**LEGAL ADVERTISEMENT
PORTLAND PLANNING BOARD MEETING**

RE: **Conditional Use Review of Drive Through added to Proposed Reconstruction of Rite Aid Pharmacy**
709-713 Congress Street
Skowhegan Plaza Limited Partnership, Applicant
Project #: #2014-054 (Conditional Use) and #2013-248 (Site Plan)
CBL 047-C019-001

421 Warren Ave – Portland, Maine
Existing Site Photographs
(FST JN SP-M104)

ENGINEERS FST Since 1994 FAY, SPOFFORD & THORNDIKE, INC. ENGINEERS • PLANNERS • SCIENTISTS 778 MAIN ST, SUITE 8, SOUTH PORTLAND, ME 04106	
DRAWN: CMW	DATE: NOVEMBER 2013
DESIGNED: SRB	SCALE: AS NOTED
CHECKED: SRB	JOB NO. SP-M104
FILE NAME: SP-M104-GRAVEL WETLAND SECTIONS	
SHEET	C-4.2

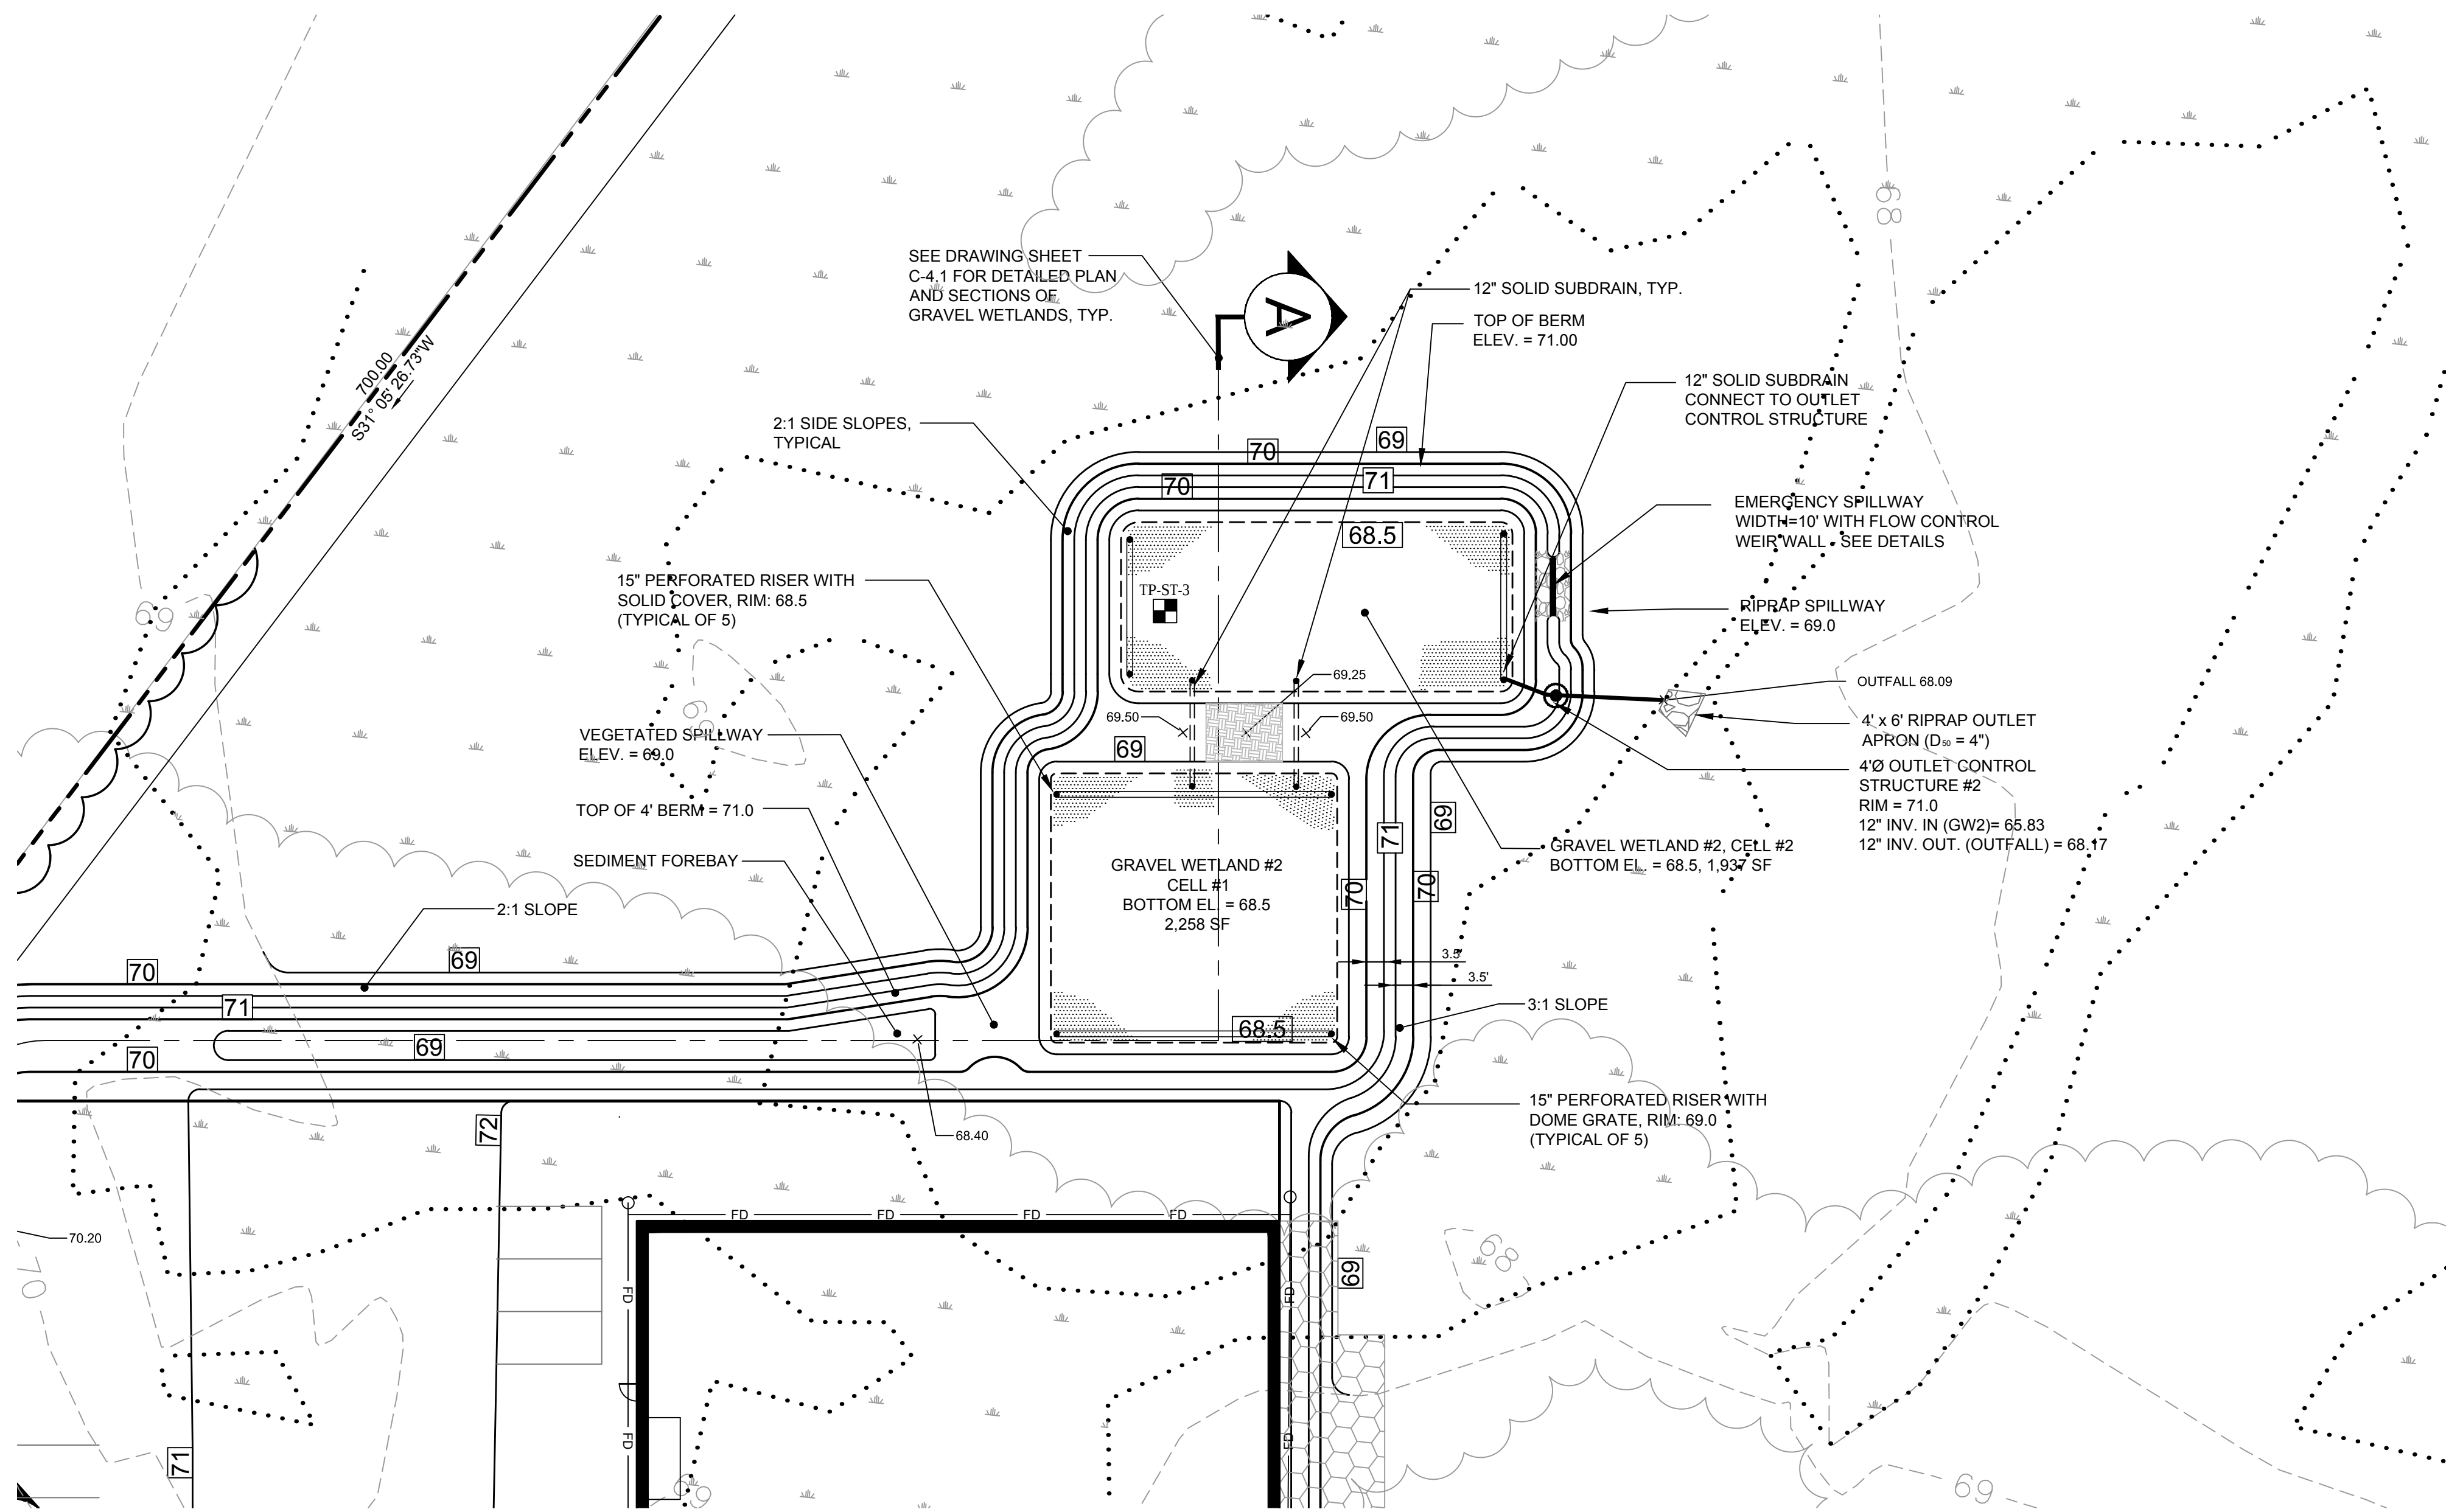
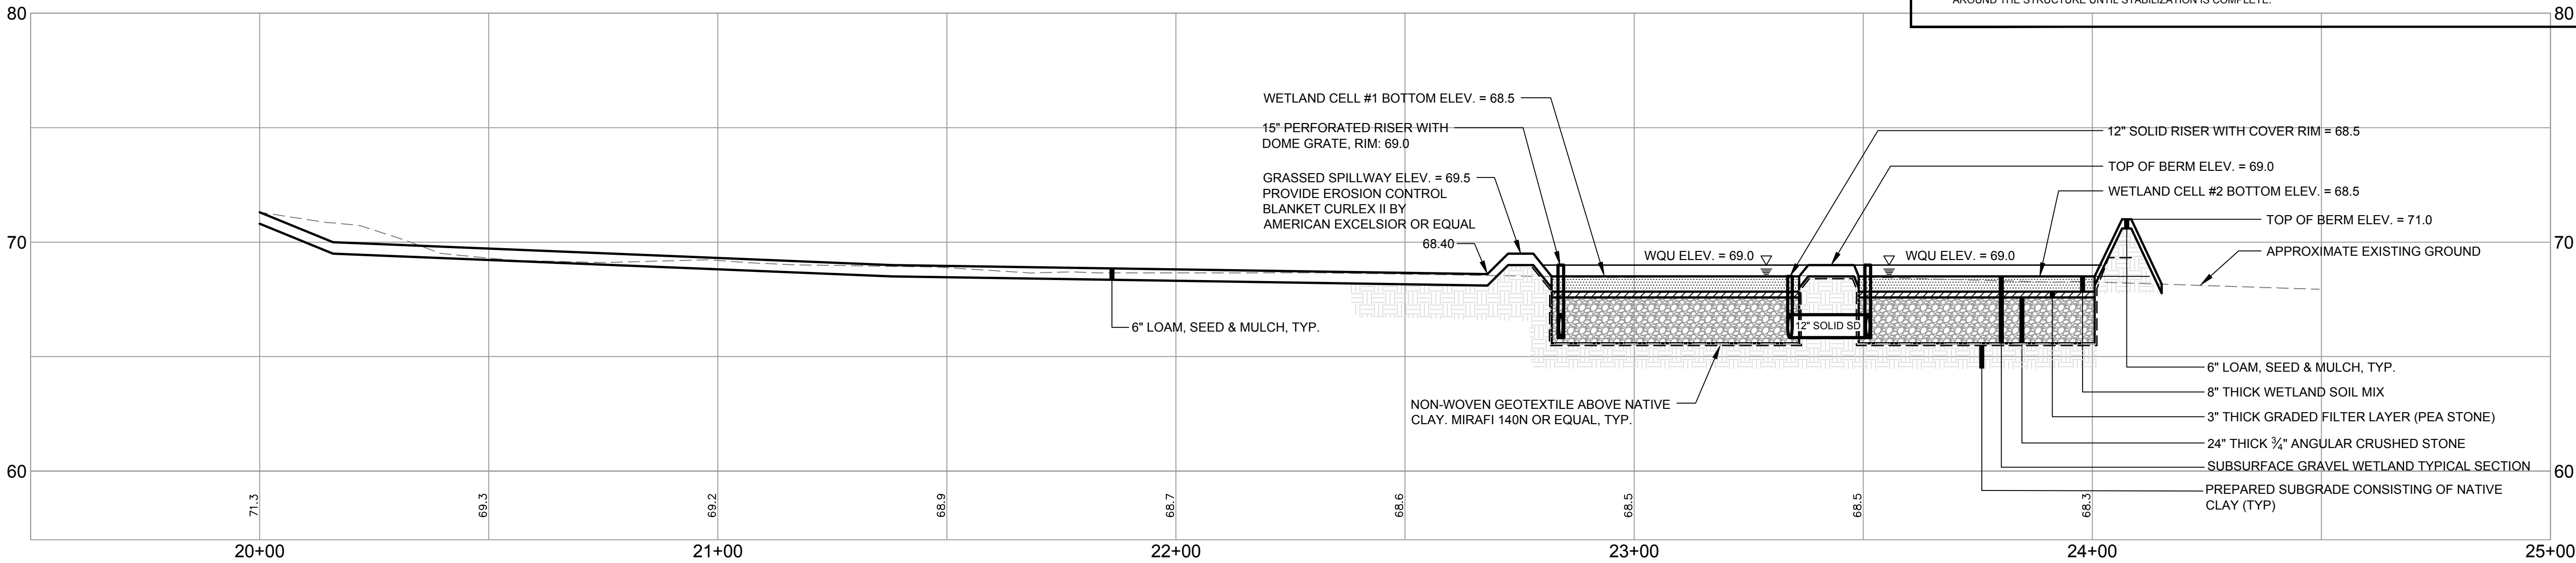
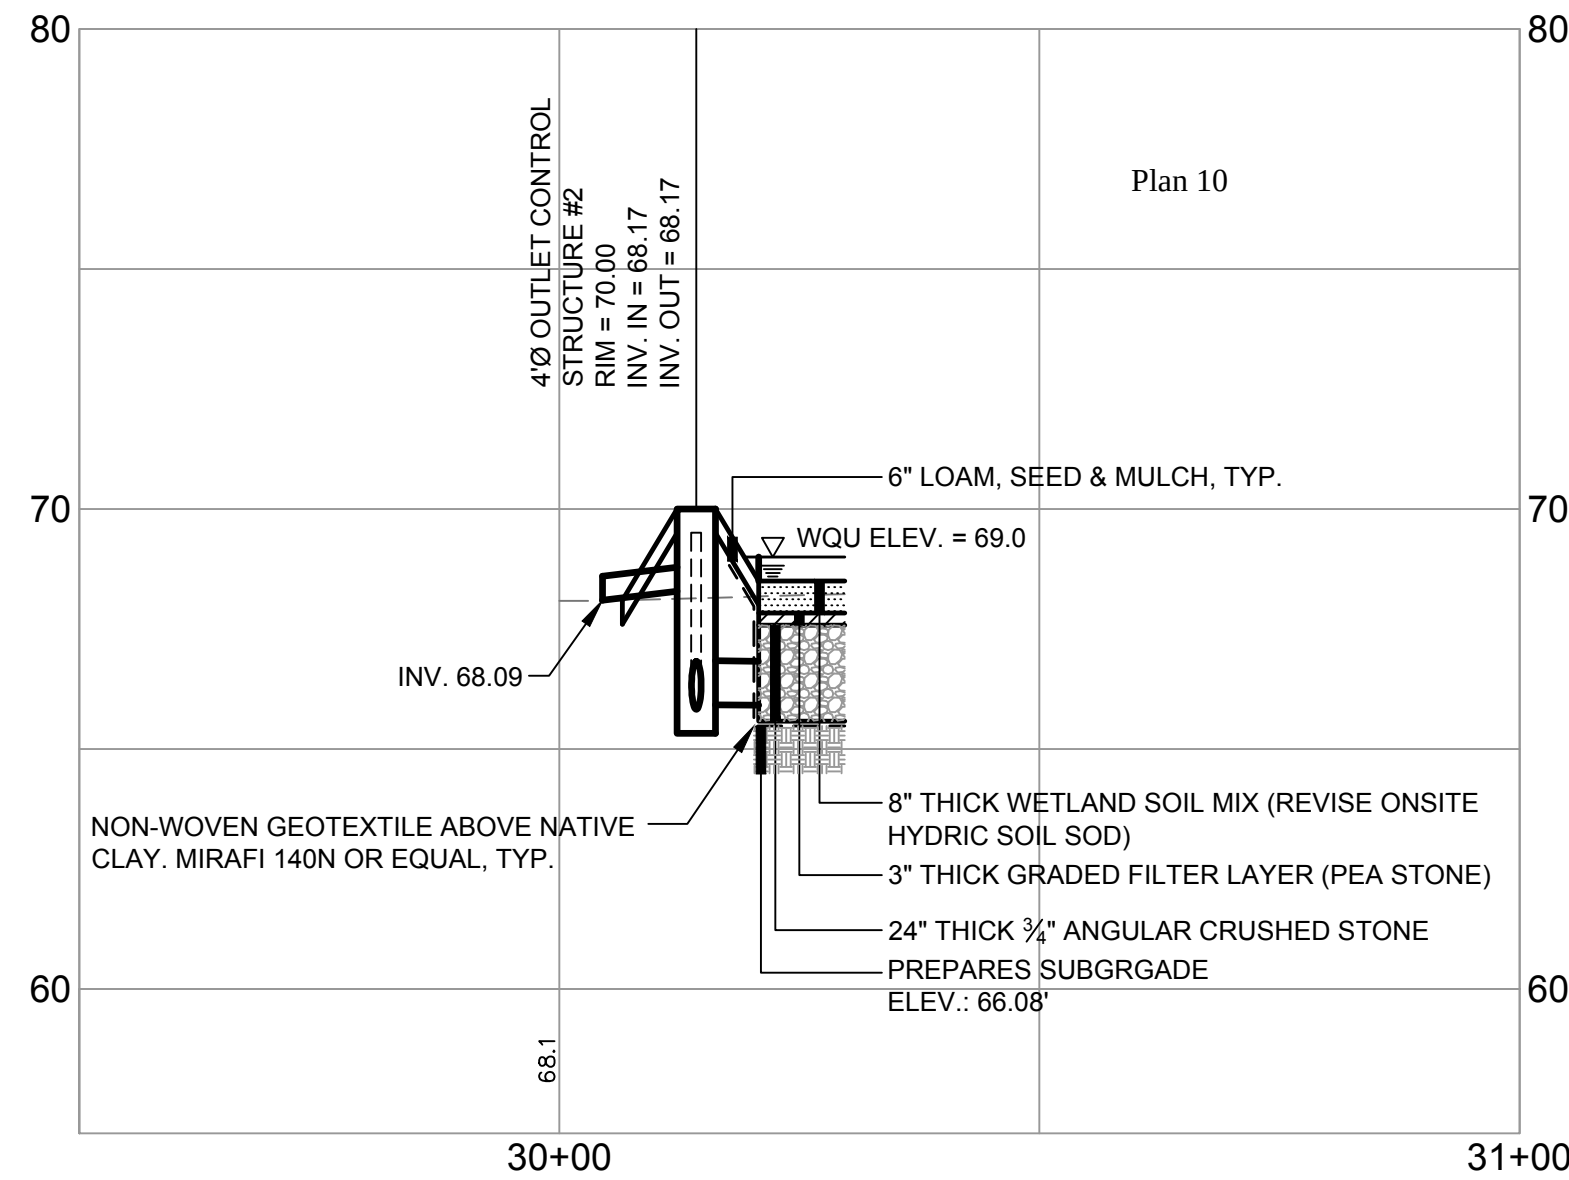
- 6) *Gravel Wetland Design Comments:*
 - a) On Sheet C-4.2, the titles for the plan view and section view incorrectly note Gravel Wetland #1; these should state Gravel Wetland #2.

- a) On Sheet C-4.2, the titles for the plan view and section view incorrectly note Gravel Wetland #1; these should state Gravel Wetland #2.*

Sheet C-4.2 has been corrected to state Gravel Wetland # 2.
